SUBJECT: Development Review Report
& Notification of Readiness

PLAT NAME: Vista Gardens Ballroom

PLAT NO: 020-MP-19

Board of County Commissioners, Broward County, Florida
 Environmental Protection and Growth Management Department
 Planning and Development Management Division
 DEVELOPMENT REVIEW REPORT

SKETCH OF BOUNDARY SURVEY

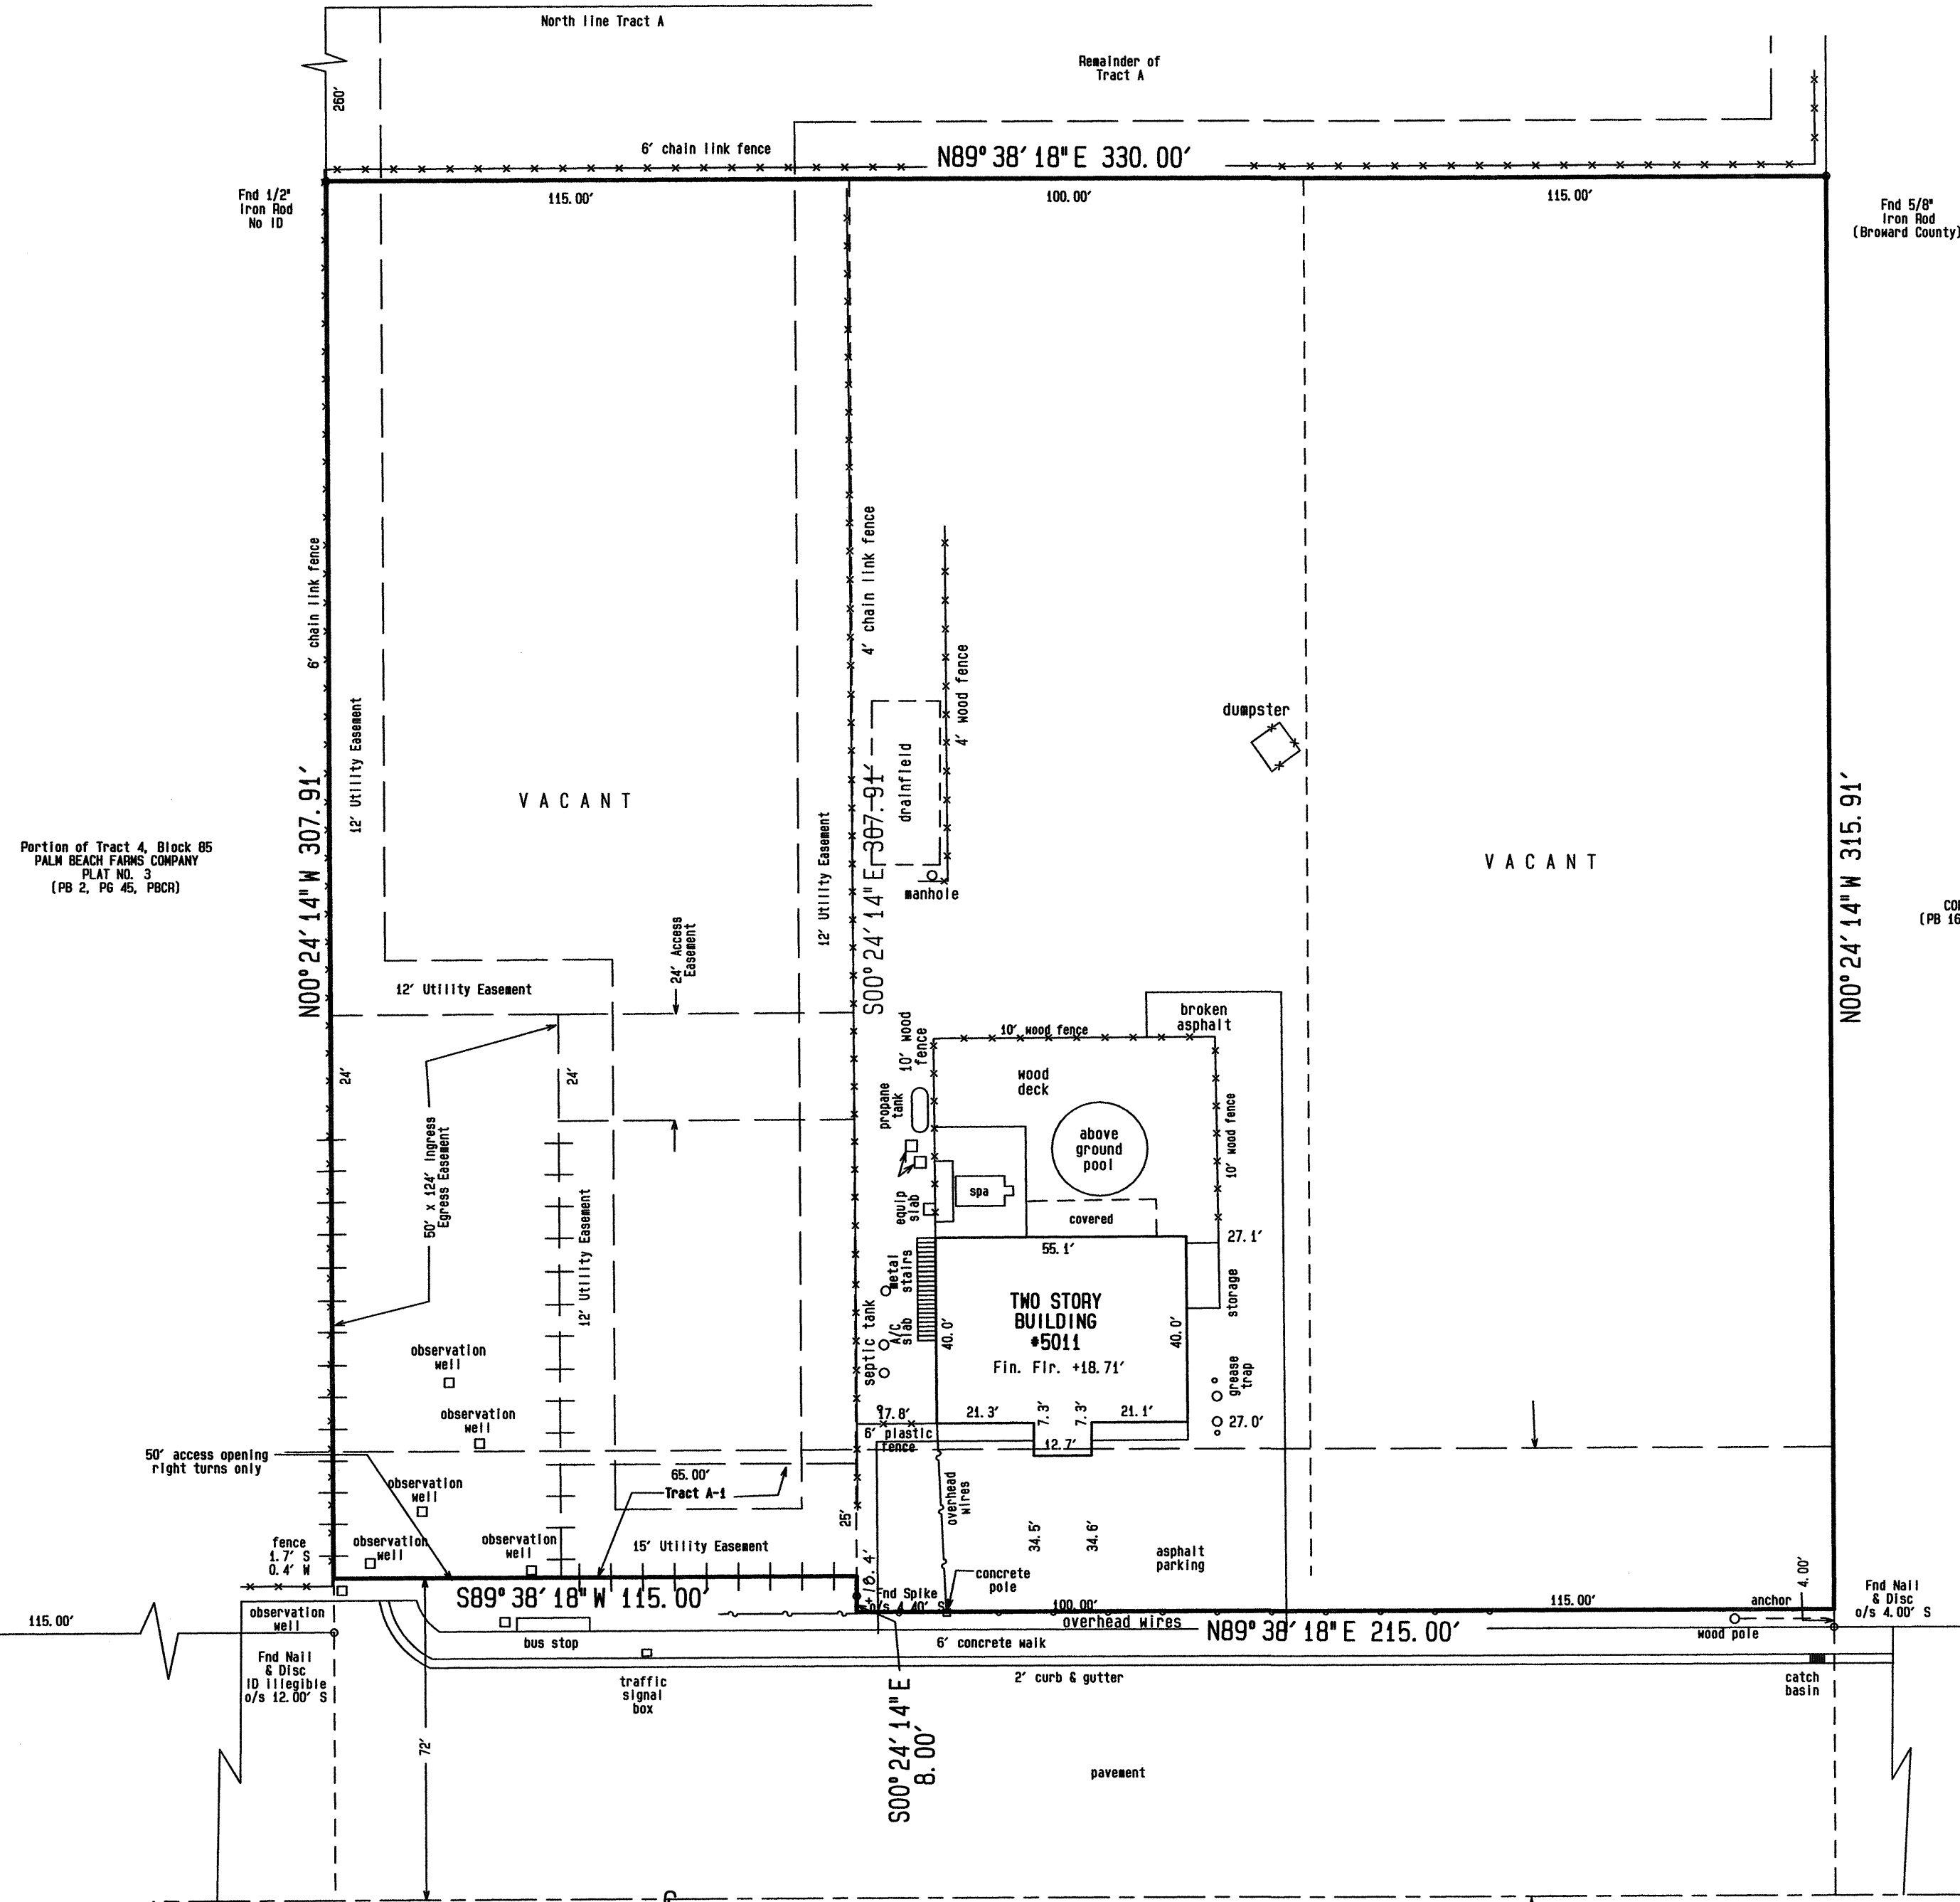
- 1. Verify the north – south dimension of the underlying TRACT 3 in BLOCK 85 per P.B. 2, PG. 45, P.B.C.R. The plats recorded in P.B. 160, PG. 15, B.C.R.; P.B. 164, PG. 45, B.C.R. and P.B. 174, PG. 18, B.C.R. east and west of this plat appear to indicate the north – south dimension of the Tract is 660.5' +/- . The sum of the north – south dimensions shown on this plat ($315.91' + 60' + 280' = 655.91'$) differs from that. Review and revise as necessary.

- 2. Verify the north – south location of the south plat boundary line. The description calls for the line to be 60 feet north of the south line of TRACT 3. The south line of the plat as shown on the drawing appears to be 64 feet north of the Tract line. Review and revise as necessary.

- 3. Revise the line weight and PLAT LIMIT label on the south plat boundary as necessary, based on the above comment.
 - 4. Review the labels on the east and west plat boundary lines and revise as necessary.

- 5. For clarity, consider adding labels to the east and west plat boundary lines to indicate they are coincident with the boundary lines of the east and west abutting plats.

- 6. Label the west line of TRACT 3 and show a distance from the line to this plat.
- B. Revise the bearings on the plat boundary to run all in a clockwise or counterclockwise direction.

- E. Full dimensioning and square footage shall be shown on all dedicated RIGHT-OF-WAY.
- F. The Fnd Nail & Disc adjacent to the southeast corner of the plat does not qualify as a PRM as defined in Florida Statutes, Chapter 177.031(15). Review and revise as necessary.

- H. The Survey provided with the initial submittal of the plat does not meet the standards outlined in Broward County Land Development Code Sec. 5-189(b)(4). Review and revise as necessary. Provide the revised survey prior to submittal of the plat mylar.

- E. Illustrate the north – south relationship of the south line of the underlying TRACT 3 and the centerline of construction of State Road 810. The plats recorded in P.B. 148, PG. 10, B.C.R. and P.B. 176, PG. 123, B.C.R. appear to indicate that they are not coincident. Review and revise as necessary.

- G. Reconcile the north – south location of the south plat boundary line/north right-of-way line of State Road 810. The F.D.O.T Right-of-Way map Section 86120-2508 shows the north right-of-way line as being 64 feet north of the centerline of construction. Review and revise as necessary.
